Beaver Valley Power Station, Unit No. 1  
Docket No. 50-334, License No. DPR-66  
Completion of Required Action by NRC Order EA-12-051, Reliable Spent Fuel Pool  
Instrumentation (TAC No. MF0799)

1. Compliance with Order EA-12-051
2. NRC Requests for Information

NRC Requests for Information  
Page 1 of 39

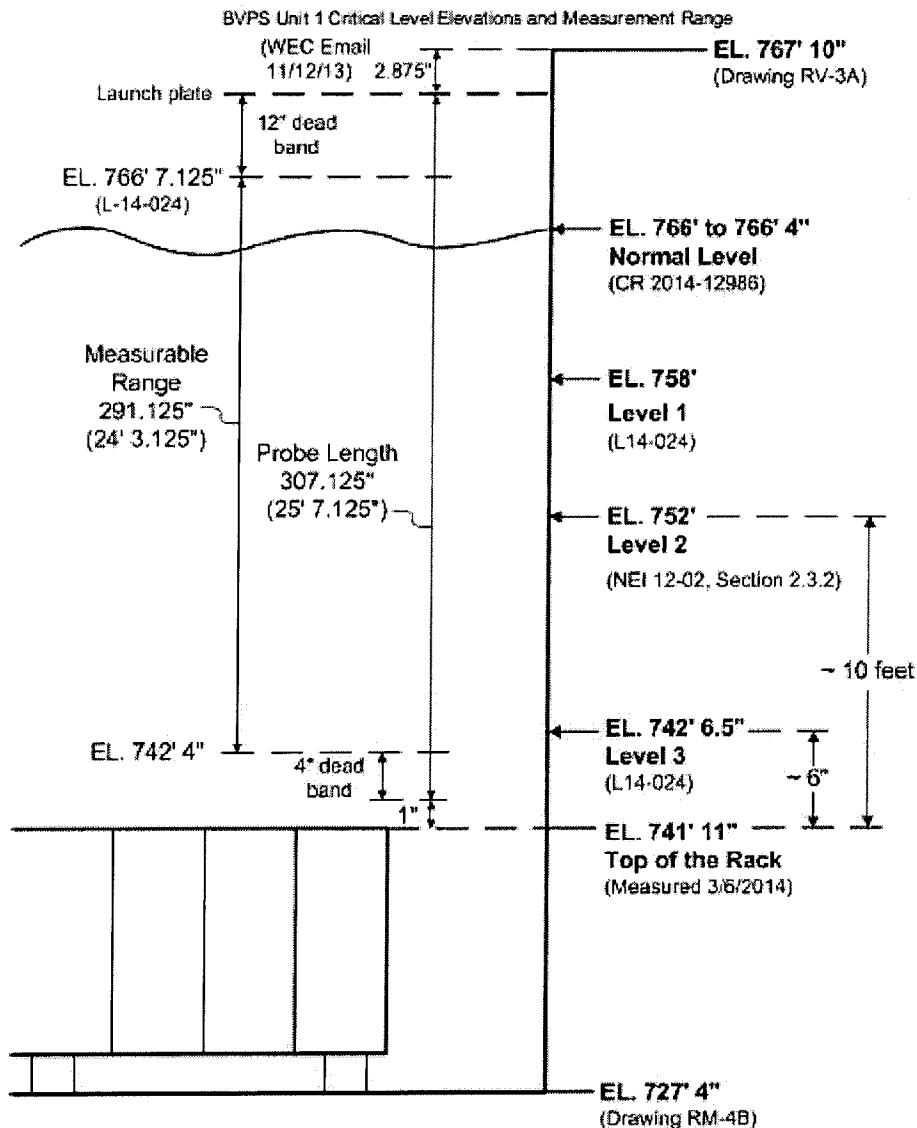
**RAI-2:**

**Please provide a clearly labeled sketch depicting the elevation view of the proposed typical mounting arrangement for the portions of the instrument channel consisting of permanent measurement channel equipment (e.g., fixed level sensors and/or stilling wells, and mounting brackets). Indicate on this sketch the datum values representing Level 1, Level 2, and Level 3, as well as the top of the fuel racks. Indicate on this sketch the portion of the level sensor measurement range that is sensitive to measurement of the fuel pool level, with respect to the Level 1, Level 2, and Level 3, datum points.**

By letter dated February 27, 2014, FENOC provided a sketch depicting the requested datum values. Subsequently, more refined measurements were obtained for the top of fuel rack and bottom of measurement range. An updated sketch is provided below.

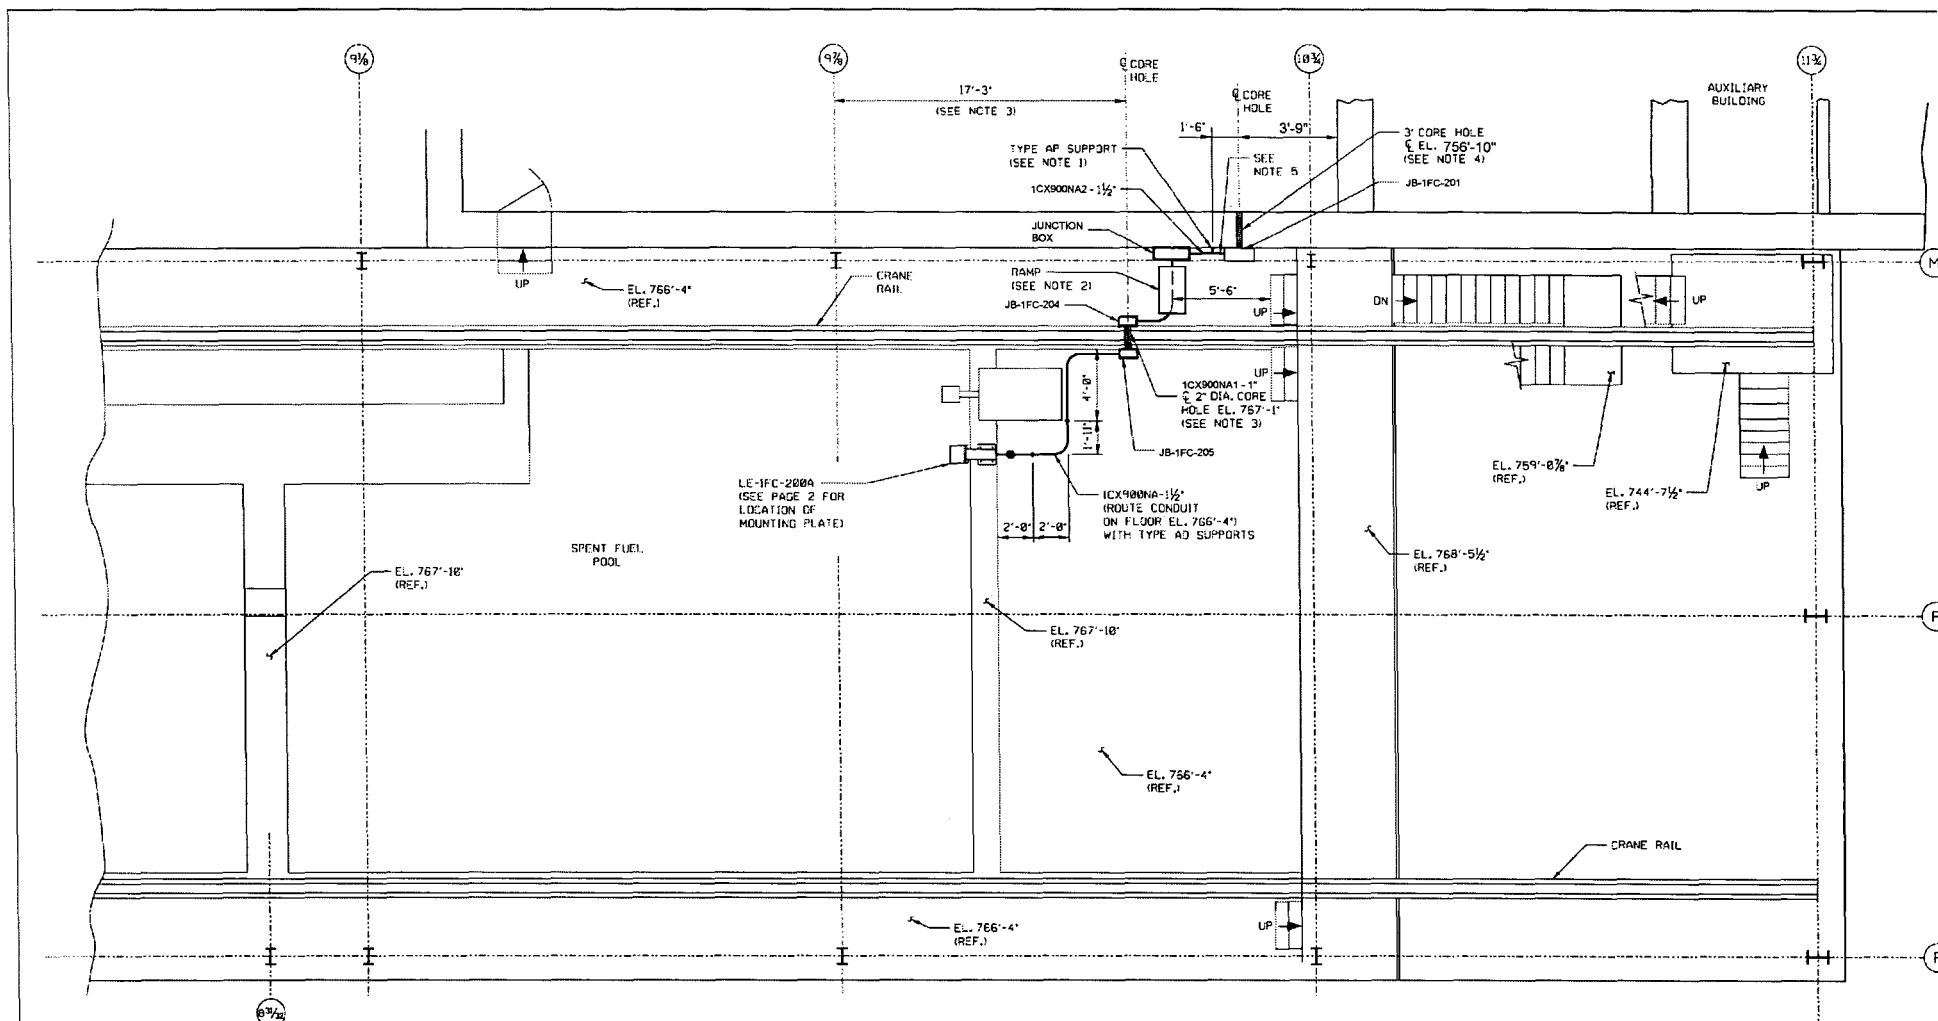
**RAI-3:**

**Please provide a clearly labeled sketch or marked-up plant drawing of the plan view of the SFP [spent fuel pool] area, depicting the SFP inside dimensions, the planned locations/placement of the primary and back-up SFP level sensor, and the proposed routing of the cables that will extend from these sensors toward the location of the read-out/display device.**

The response to this RAI was provided by FENOC letter dated February 27, 2014. Subsequently, by FENOC letter dated February 26, 2015, the design for BVPS-1 progressed from conceptual design to final design. As a result, some of the locations of the instrumentation and conduit routing were changed. Updated sketches are provided below, depicting general configuration. Previous versions of these sketches were made available to the NRC staff for review.

The electronics enclosure units (transmitters) are located in an area removed from the SFP environment, which would be accessible in the event of a beyond-design-basis external event (BDBEE) that would restrict access to the SFP. The enclosures for the two instrument channels are separated to minimize the possibility of a single event damaging both channels. The primary level indicating transmitter LIT-1FC-200A is located on the west wall of the auxiliary building, general area elevation (El.) 735' 6", just east of the stairwell. The backup level indicating transmitter LIT-1FC-200B is located on the west wall of the auxiliary building, general area El. 735' 6", just east of the stairwell. The level transmitters located in the auxiliary building have a local display, although the credited display units will be located in the main control room (MCR). Cabling for each channel is run in separate conduits and cable trays to the control room indicators.

The primary electronics enclosure PNL-1FC-200A (control room analog indication) is located on the south wall of the old Shift Manager's Office in the control room, El. 735' 6". The backup electronics enclosure PNL-1FC-200B is also located on the south wall of the old Shift Manager's Office in the control room, El. 735' 6".
